Muzzi Moto Limited Oaklands Business Centre Coppenhall Stafford ST18 9BW Phone: 01785-224444

SILENT HEKTIK – CDI changes

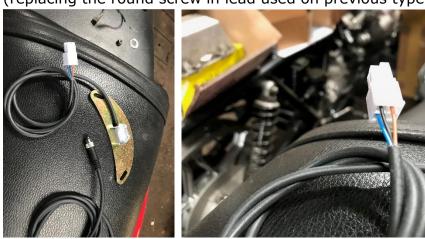
Hall sensor pick-up.

3 x hall sensor pick-up wires, these fit on the four-pin connector as follows (replacing the round screw in lead used on previous type).

CDI feed wires.

5 x wires now fit on the six pin plug direct into the CDI box (i.e. not via a male/female connector). As per the following wiring diagram.
